| **Subject:** | RE: Labelling on HL7812 |

Sierra Wireless is in the process of applying for IC certification for a radio module Model HL7812.

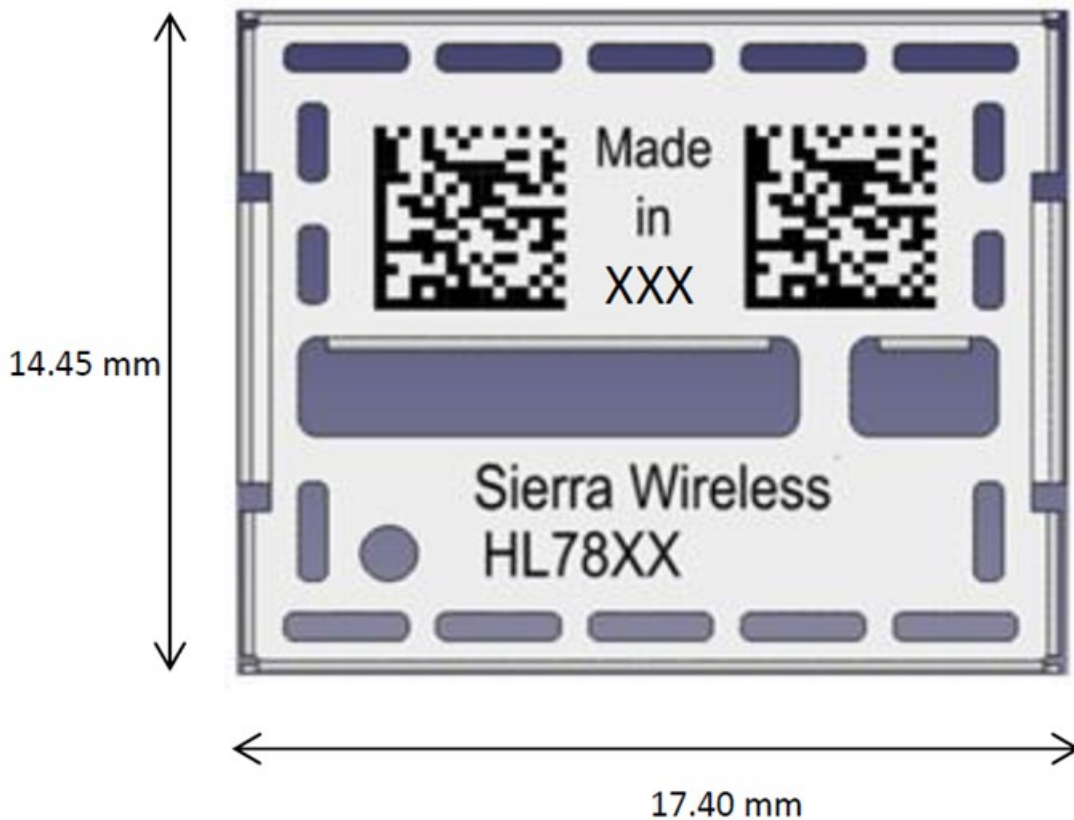
In an effort to reduce the amount of paper/plastic/adhesive label consumption and be a good environmental corporate role model, Sierra Wireless uses laser etching instead of the traditional labels for the module.
The laser etching process requires a "no etch" circular area in the centre of the module so that modules can be picked up by vacuum nozzles.

The photo and dimensions of the module are shown below.

Due to the small size of the product and the "no etch" area (marked grey) required for the laser etching process, it is not practical to mark the FCC Identifier and IC certification number in a font size of 4 points or larger.  Pursuant to FCC Rule §2.925, the FCC Identifier will be placed in the user manual and on the device packaging.  Sierra Wireless hereby seeks agreement from ISED to place the IC certification number in the user manual in accordance with Section 4 of RSS-Gen Issue 5.

Your proposal is acceptable. Please place the product label information in the product manual.
